4 June 2024

Milldale Stage 5 – Post Development Flood Levels

Memorandum - Post Development Flood Levels - Stage 5 Milldale.

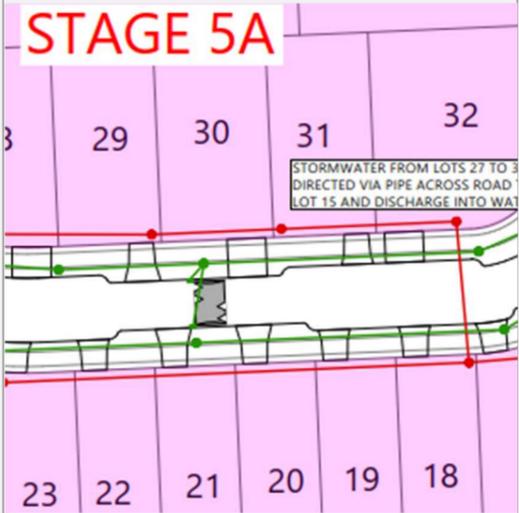
b)	Closed	<p>There are several pipes proposed in the side and rear yards of private lots. Please confirm what mechanisms are proposed (e.g. side and rear yard restrictions) that will:</p> <ul style="list-style-type: none"> Prevent future land owners to build over these pipes 	<p>The pipes in question will be public drainage lines. Auckland Council Code of Practice requires any building works in proximity to public drainage and any future building to adhere to these standards.</p>	<p>Subject to EPA. Minimum design requirements in accordance with Auckland Council Stormwater Code of Practice Section 4.3.9.1 shall be achieved.</p>

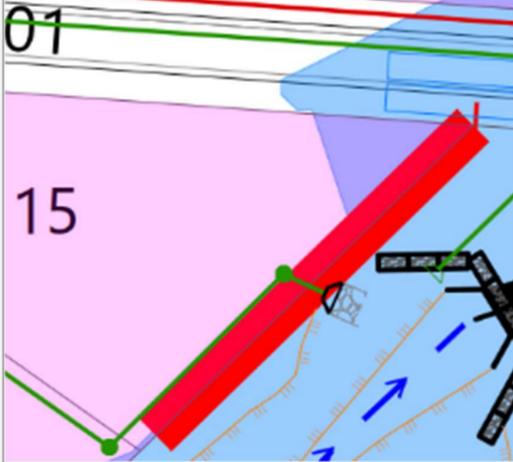
c)	Closed	<p>Please clarify the note on plan 3001 below. There appears to be a discrepancy between the note and the stormwater reticulation shown. In particular, the pipes servicing these lots are also collecting road runoff, so hydrology mitigation for these roads will not be provided in case this network is discharging directly to the stream.</p> 	<p>The note is an error and should be disregarded. With the updated BPO assessment, the alignment of the stormwater reticulation will be amended.</p>	<p>Please provide the updated plans for review.</p>	<p>See revised set of resource consent engineering plans that include the revised series 3000-DR drawings for the new stormwater reticulation layout. The revised drawings include the removal of the note in question.</p>

d)	Closed	<p>The proposed location/orientation of the outfall integrated within the culvert inlet structure is not appropriate. Positioning the outfall opposite the stream flow</p>	<p>With the updated BPO assessment, the alignment of the stormwater reticulation will be amended.</p>	<p>Please provide the updated plans for review.</p>	<p>Refer to drawing P20-248-05-3873 for the revised design.</p>

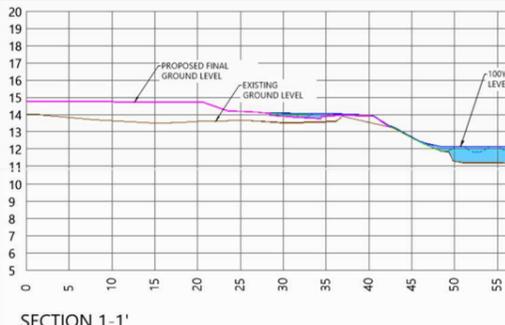
#	Status	HWD issues raised Date: 23/02/2022	Applicant Response Date: 18/03/2022	HWD response Date: 14/04/2022	Applicant Response Date: 03/04/2022	HWD response Date: 03/06/2022
				<p>clustering/intensification as it has been acknowledged in the pre-application meetings that the developer has commitments to the government to deliver an agreed number of houses.</p> <ul style="list-style-type: none"> • Larger, centralised devices generally have lower lifecycle costs than smaller scattered devices. This applies to both end-of-line and roadside devices. The BPO assessment discussed above is expected cover this, but would be good to understand the reasoning behind removing the basin previously presented through the pre-application process (Basin 5A P9). • Any proposed centralised devices should demonstrate how ongoing operation and maintenance can be carried out e.g. safe access to inlet and outlet structures for inspection and repair, safe access for machinery at asset renewal stage, safe access for landscaping maintenance, etc.. • Public hard engineering solutions such as underground tanks, structurally encased devices (including retaining walls) and proprietary devices are not supported and will only be accepted in cases where the assessment demonstrates no alternatives are practicable. • Although not necessarily related to this application, wetlands cannot be automatically excluded based on predisposition of safety in design (drowning) and elevated temperatures associated with standing water as these can be managed through standard design
